| Hudson Planning Commission | CONCEPT SITE PLAN REVIEW – DAY CARE |
| Case No. 26-73 | March 9, 2026 |

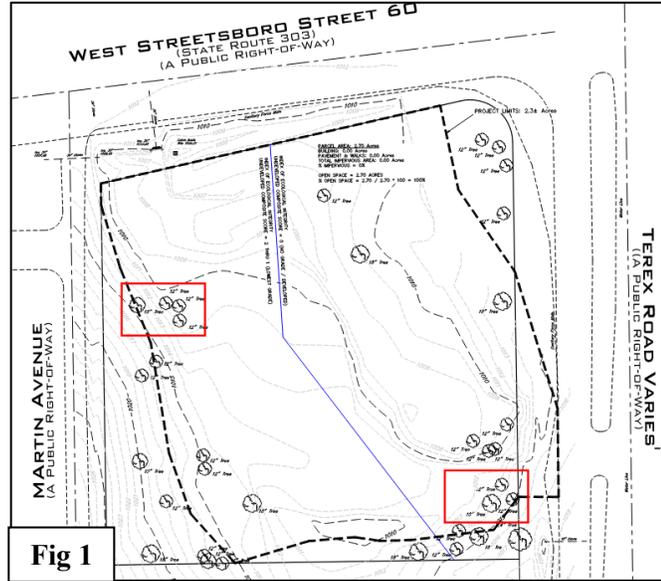
Section 1207.18(b)(5) - Tree Protection: Staff notes there is opportunity to preserve existing trees on the south and west sides of the property abutting Martin Drive properties. Question if additional trees can be preserved along the areas highlighted in Figure 1.

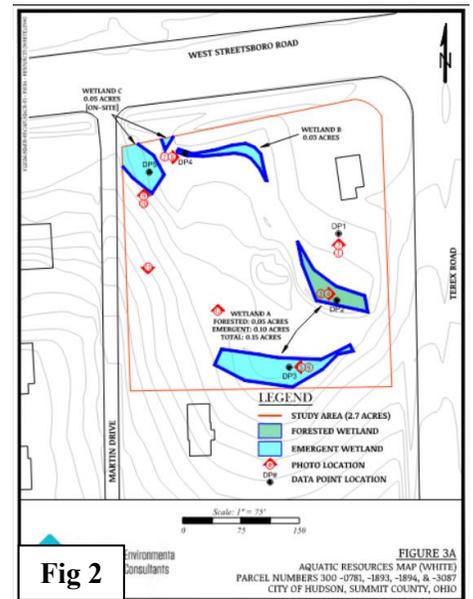
Section 1207.18(b)(6) - Wetlands/Stream Corridor Protection: Staff notes there are three wetlands onsite. These are labeled A, B, and C in Figure 2. These wetlands have been identified in the City’s Index of Ecological Integrity, though have scored under the lowest composite. The applicant proposes the following:

1. Convert Wetlands B and C along W. Streetsboro St. into a stormwater pond.
2. Fill the portion of Wetland A that is located in the center of the property in order to construct the parking lot.
3. Regrade the majority of the portion of Wetland A that is located along the southern property line.

- Question the current category of the wetlands. Within District 6 and 8, the LDC requires a 100 ft setback for Category II and III wetlands and no setback for Category I. Category I wetlands are low-quality wetlands with minimal ecological functions. Staff understands Category I wetlands were once present on the site based on previous approvals.

- Question if the southern portion of Wetland A could be preserved by shifting the proposed improvements closer to W Streetsboro Street. This would also provide additional natural buffer between the residential property to the south. Staff has reviewed the applicable setbacks further following the pre-application meeting and determined a 50 ft building setback and 25 ft parking lot setback can be applied along the W. Streetsboro St. frontage.

Fig 3

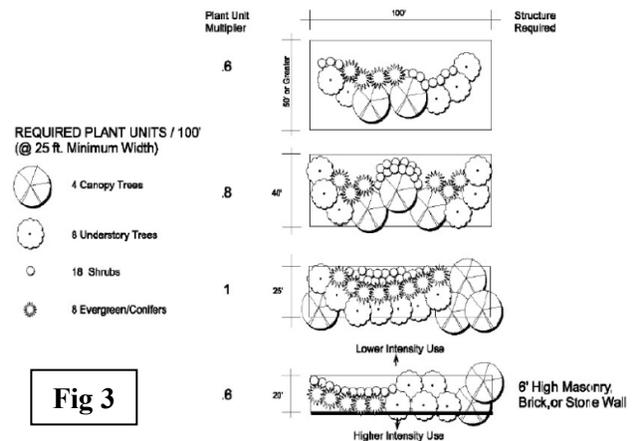
- A landscape Bufferyard D (See Figure 3 below) shall be installed along the side and rear boundaries of the development adjacent to residentially zoned or used property. Staff notes this bufferyard may be expanded based on the conditional use criteria. Additional trees may count towards the requirement. Question how the bufferyard would be established along the southern property line to meet this requirement.
